NAME: INST. - FURN - RADAR OPERATOR'S CURTAIN SUPP.

CONSOLIDATED AIRCRAFT CORP. SAN DIEGO, CALIF.

SIZE J | 28F6945

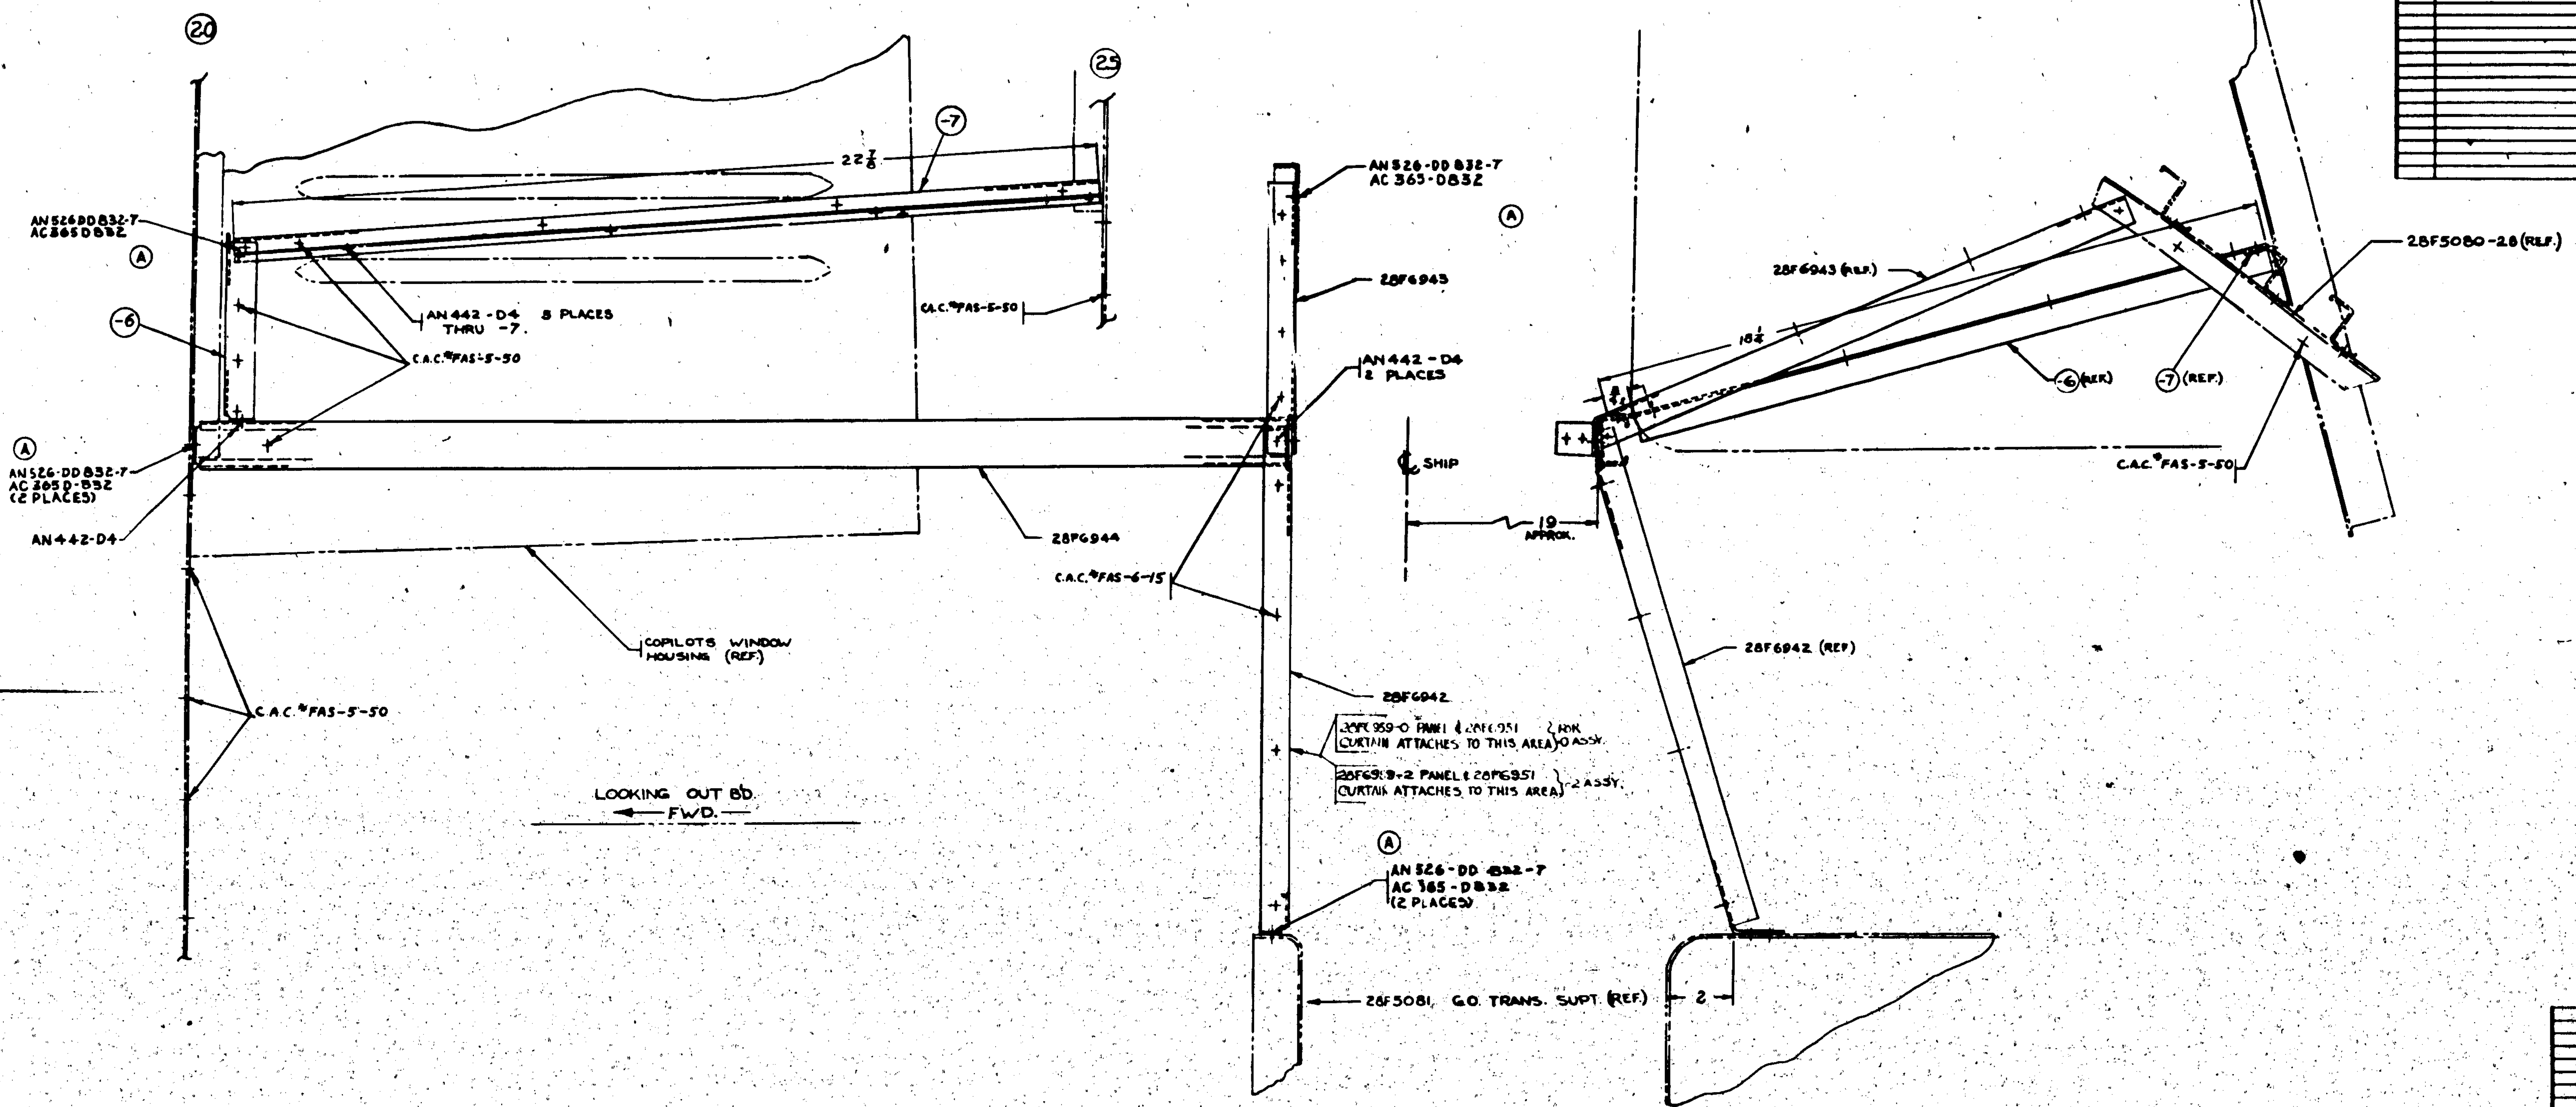
LET	ALTERATION	DATE	BY
A	ON FACE OF DWG. AN526-DD832-7 (6 PLACES) & AC365-D832 (6 PLACES) WAS AN442-D4. ADD TO P.L. AN526-DD832-7 (6) & AC365-D832 (6) WAS (...)		E.O.
B	CREATED -2 ASSY SAME AS -0 ASSY EXCEPT THAT 28F6959-2 REPLACES 28F6959-0 PNL. -2 REPLACES -0
